Subject: Response to Technical Assistance Request – Vapor Assessment and Mitigation
Cobblestone Hotel & Suites
1407 16th Street, Two Rivers, WI 54241
BRRTS #: 07-36-587700

This letter is written in response to a Technical Assistance (TA) Request that included the *Passive Vapor Mitigation System Installation Report* submitted on your behalf by EnviroForensics, LLC (EnviroForensics). The request was received by the Wisconsin Department of Natural Resources (DNR) on August 24, 2020, with the \$700 review fee as required by Wisconsin Administrative Code (Wis. Admin. Code) § NR 749.04(1). DNR had calls with the property owner (Two Rivers Hotel Group, LLC) and EnviroForensics in October and November 2020. On November 11, 2020, the DNR required additional actions prior to being able to provide a response to this TA request. The additional actions were completed and documentation was received on April 7, 2021, in a letter titled *Vapor Intrusion Assessment Results* submitted on your behalf by EnviroForensics. The DNR then reviewed the documentation to provide a final response to the TA request.

Cobblestone Hotel & Suites
 1407 16th Street
 Two Rivers, Wisconsin

Figure	1
Project	300040

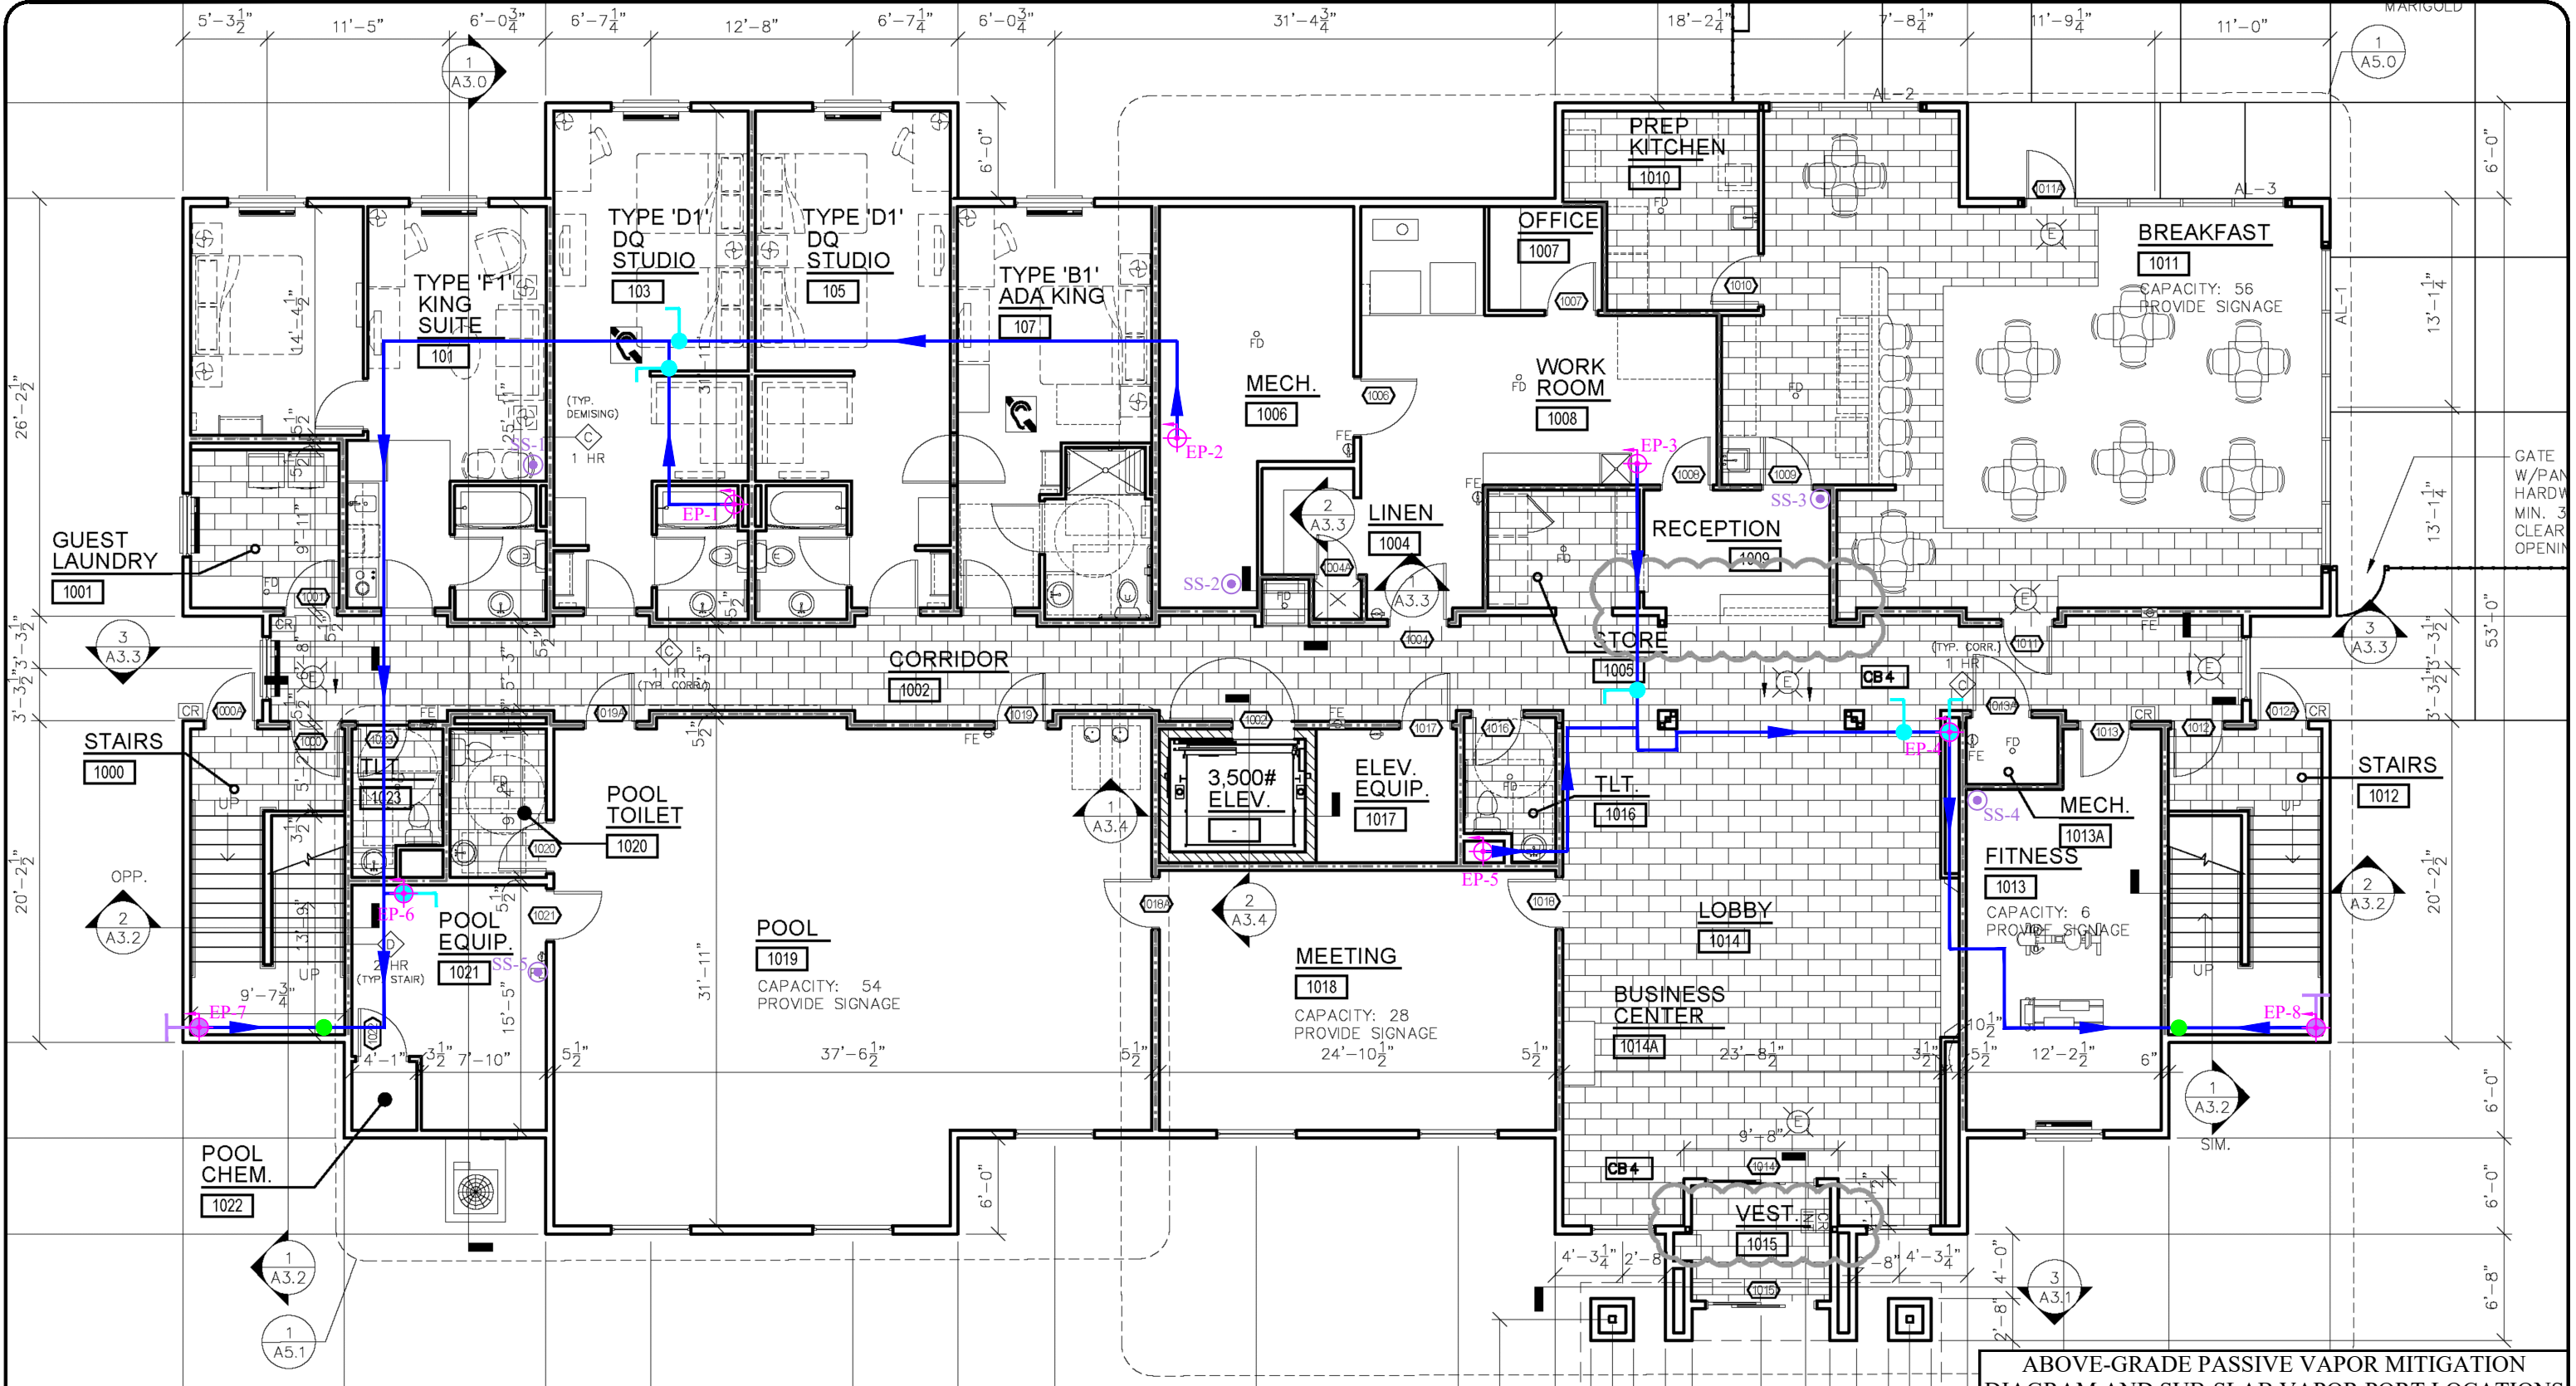
These additional actions were completed in February and March 2021 and documented in the letter *Vapor Intrusion Assessment Results* submitted to the DNR on April 7, 2021. The five sub-slab sampling locations were re-sampled in February 2021. One of the samples (SS-2) had an anomalous result, so it was re-sampled again in March 2021.

- 1) There is not a risk of vapor intrusion to the hotel based on what is currently known; therefore, a vapor mitigation system is not required to operate at this time as a continuing obligation.
- 2) The data from the February 2021 vapor sample from SS-2 is considered an anomaly and was discounted based on the following:
 - No identified source for tetrachloroethene (PCE) beyond occasional low level PCE detected in groundwater;
 - Indoor air data from the elevator shaft had no detections above the vapor action levels (VALs);
 - Receptor is a hotel (transient population); and
 - All other sub-slab/sub-membrane vapor data collected was below vapor risk screening levels (VRSLs).

- 3) The DNR reviewed the documentation of the elevator shaft construction and determined the construction was adequate based on the following:
 - The indoor air data from the elevator shaft showed no exceedances of the VALs;
 - Presence of the vapor barrier and passive system surrounding the elevator shaft;

- Presence of the 60-mil waterproof membrane along the sides of the elevator shaft;
 - Receptor is a hotel (transient population); and
 - All sub-slab/sub-membrane vapor data collected was below the VRSLs, with the SS-2 data from February 2021 being discounted as an anomaly.
- 4) This property will likely be assigned a continuing obligation for potential future vapor risk at the time of case closure of the Hamilton Industries Site (Former) contamination case (BRRTS # 02-36-578316) if conditions were to change at the property in the future where a potential vapor risk could be encountered.
